## SPEEDWAY #2224 JSP17-63

Consideration at the request of McBride Dale Clarion for Preliminary Site Plan and Storm Water Management Plan approval for a new Speedway gas station facility. The subject property is approximately 2.03 acres and is located on the southwest corner of 14 Mile Road and Haggerty Road (Section 1). The parcel is zoned B-3 with a Planned Rezoning Overlay. The applicant is proposing to demolish the existing gas station and replace it with a larger convenience store with an outdoor seating area, 8 double-sided fuel dispensers, associated parking and storm water detention pond.

## PLAN REVIEW CENTER REPORT

**Review Date:** May 22, 2019  
**Review Type:** Preliminary Site Plan  
**Project Name:** Speedway at 14 Mile and Haggerty  
**Plan Date:** 4.11.19  
**Prepared by:** Lindsay Bell, Planner  
**Contact:** E-mail: lbell@cityofnovi.org Phone: 248.347.0484

**2224 - CS1**

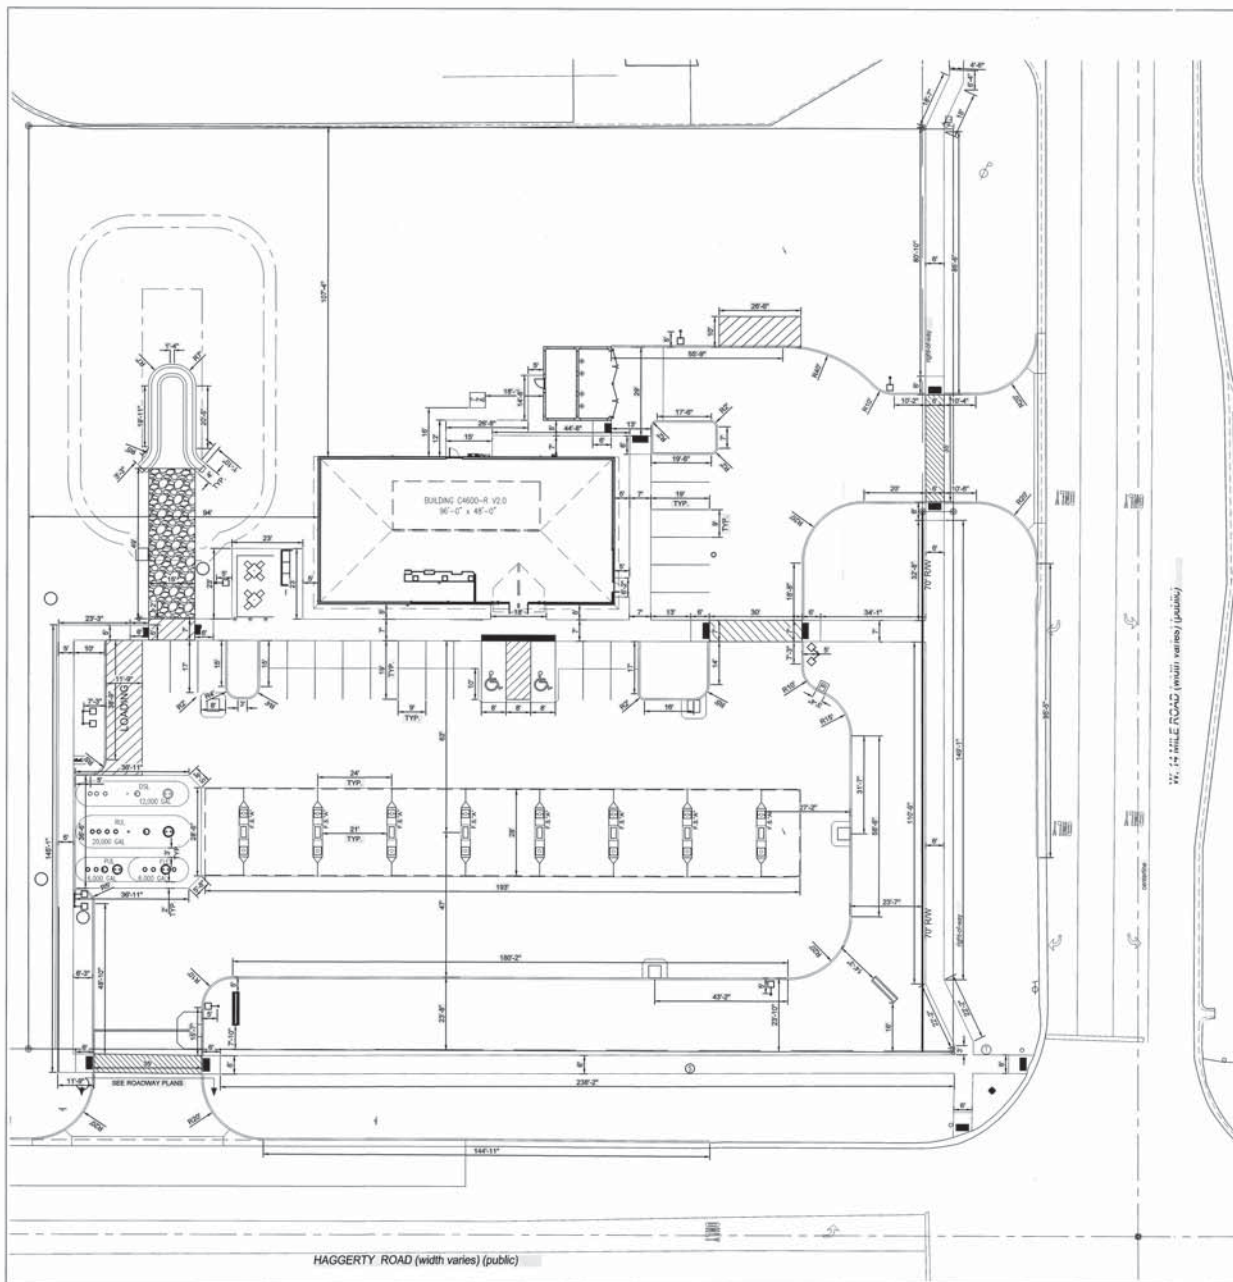
- a. The City requires one parking space per each fuel dispensing stand and one parking space for each 200 square feet of usable building space (23 spaces) which results in a total of 29 required spaces. The applicant should revise the required parking section on sheet 2224-CS to reflect 29 spaces required.

- b. The applicant has provided 38 total parking spaces including 20 standard parking spaces, 2 ADA spaces and 16 dispenser parking spaces.
- c. The applicant has generally proposed 19 foot long parking spaces with a seven inch curb. The applicant should reduce the curb height to six inches to be compliant with City standards. Reference Section 5.3.2 of the City's Zoning Ordinance for more clarification. Note E-9 on sheet 2224-CS refers to type F-4 curb which is six inches, however, the detail on sheet 2224-CS1 is type C-4 which is seven inches. The grading plans also show 6" curbs.

DATE: 8/1/20  
 DRAWN BY: A. Sait  
 CHECKED BY: R. Roosen  
 SHEET: 2224 - LP

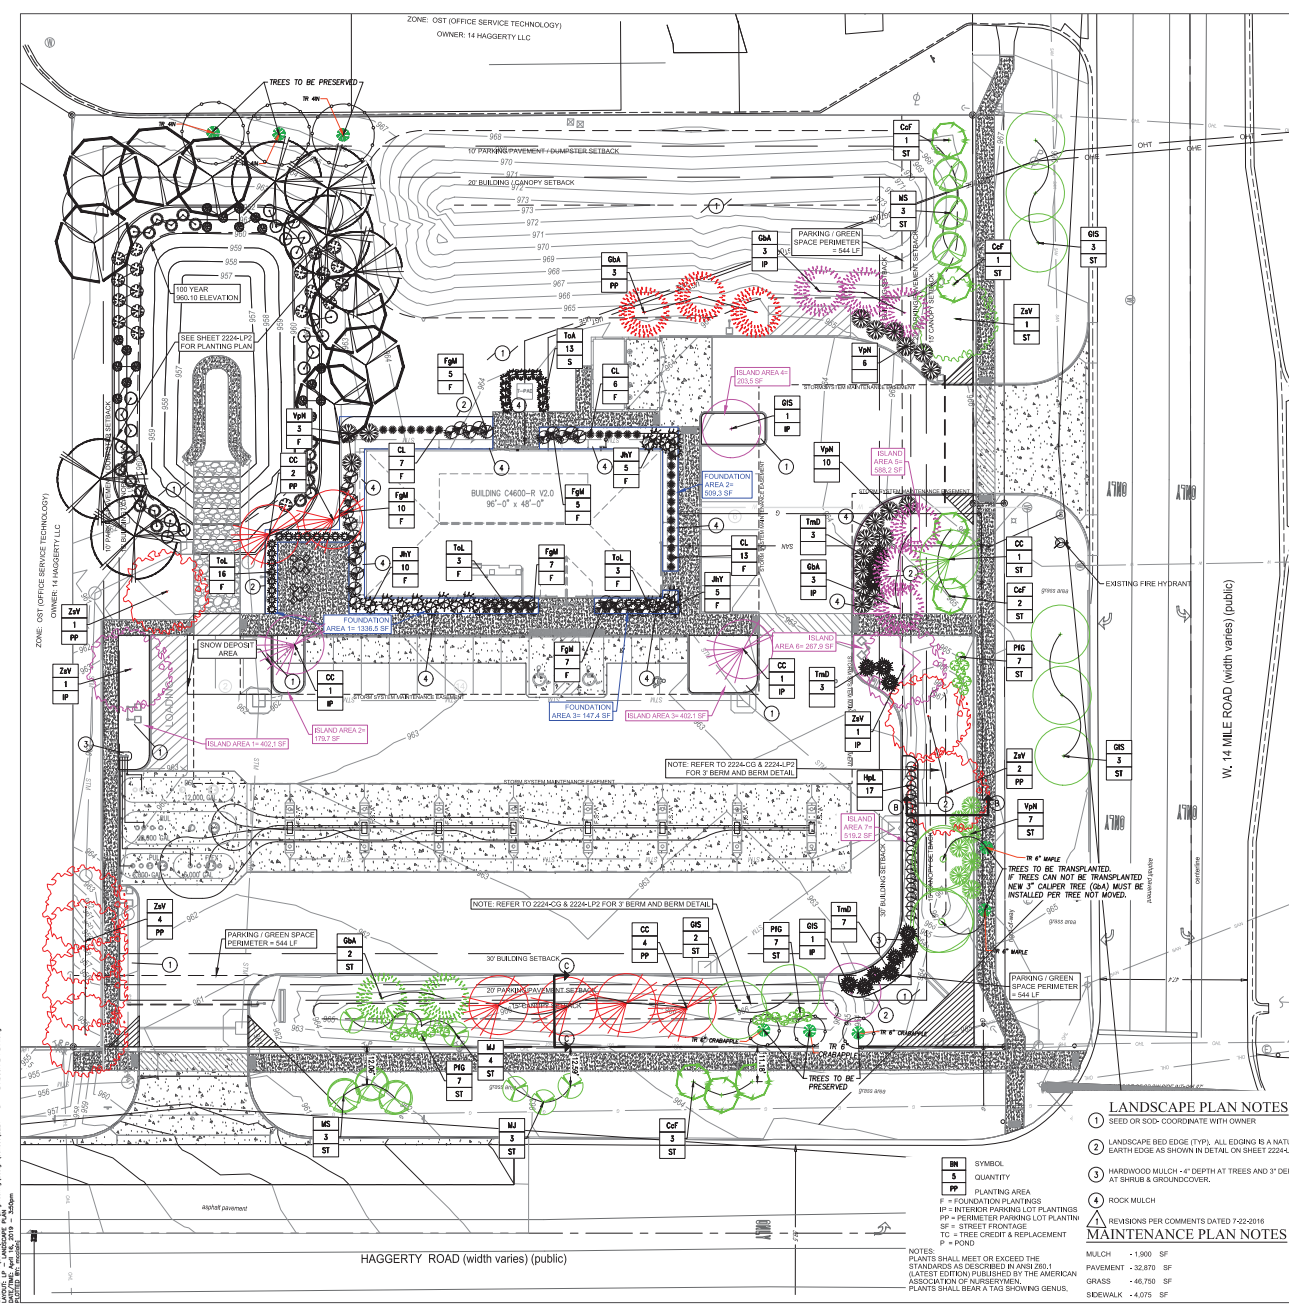
**Please copy the above notes related to the deviations to the Landscape Plan Sheet 2224-LP.**

1. Provided
2. **Please add any light posts that may exist or are proposed and resolve any tree/light post conflicts.**

1. A deviation was granted for a shortage of interior landscape area provided, but the preliminary site plan indicates the required area is actually provided now. This is great.
2. The required interior and perimeter canopy trees are provided.
3. **Please provide more spacing between the perimeter trees along the south side of the vehicular access area.**

1. Provided
2. Please revise the notes provided per the Landscape Chart.
3. **Please add a landscape estimate for the landscape plantings (trees, shrubs, seed, sod) and mulch to the landscape plan. The costs to use are:**

1. Provided
2. The woodland replacement trees do not all need to be located around the pond – they can be located in other open areas on the site as well. **Please provide more space between them (at least 20 feet).**
